**SUNDRY NOTICES AND REPORTS ON WELLS**  
*Do not use this form for proposals to drill or to re-enter an abandoned well. Use form 3160-3 (APD) for such proposals.*

Americo Energy Resources, LLC would like to change designation of the Water Supply Well #1 to an active producer and change the well name to East Shugart #90, in order to produce it from the Grayburg 4060' to 4110' perforations and the Delaware 5218' to 5955' perforations. Also for casing repair, we are requesting a variance to Onshore Order 2 requirement to run a 4 1/2" liner instead of 4' due to the following reasons. 4 1/2" flush joint liner is needed to accommodate the ESP equipment which is needed to produce large volumes. 4 1/2" flush joint liner will run from 4050' to surface inside 5 1/2" 17/23# casing and will cement all the way to surface. This will cover the damaged area of 5 1/2" at 4036', also this area is still cemented inside the 9 5/8" casing as shown in the wellbore diagram. Similarly the established 5 1/2" damage zone between 3880'-3970' is also cemented inside the 9 5/8" casing as the wellbore diagram shows. Therefore the 4 1/2" liner to be set and cemented from 4050' to surface will cover both areas.

Post WorkOver

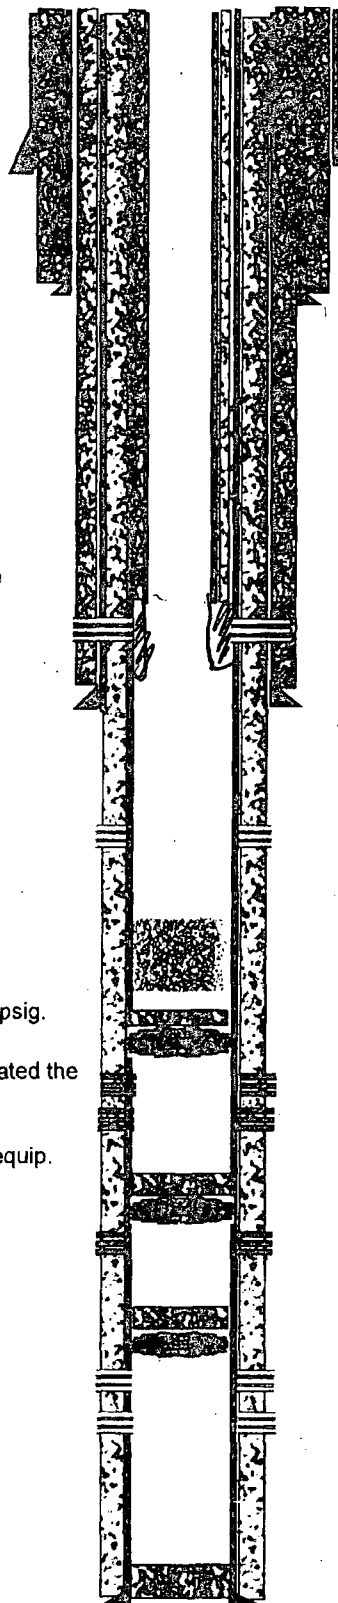
4-1/2" LinerLiner - 4010' - Surface  
on top of a BP, Cemented to surface

**Note: 4.5" casing depth has been changed to 4160' and well is remove from the unit.**

- 1. Operator is installing 3M BOP. BOP/BOPE shall be tested to 1000 psi.**
- 2. Variance is approved to run the 4.5" flush joint liner from surface to 4160'. Pursuant to a review of the casing integrity log, there are sections of the 5.5" casing that no longer exist. However, the 9-5/8" casing extends below this proposed area and it was cemented to surface. The CBL is probably showing cement behind the 9-5/8" casing in the sections where it appears that the casing integrity log shows a larger diameter than the outside diameter for the 5.5" casing. In addition, since the well has to be pumped, there will be no pressure on the thin sheath of cement that is between the 4.5" and 5.5" casing except for any hydrostatic head from a standing fluid volume. Third, the fresh water zones are protected by two other casing strings that have been cemented to surface.**

- 3. In a discussion on May 12, 2014, the operator decided to plug off the Grayburg perforations by setting the 4.5' casing deeper to 4160'. This will remove the well from the unit and operator will submit an amendment for the Unit Plan of Development stating that the well will become a producer from only the Delaware formation.**
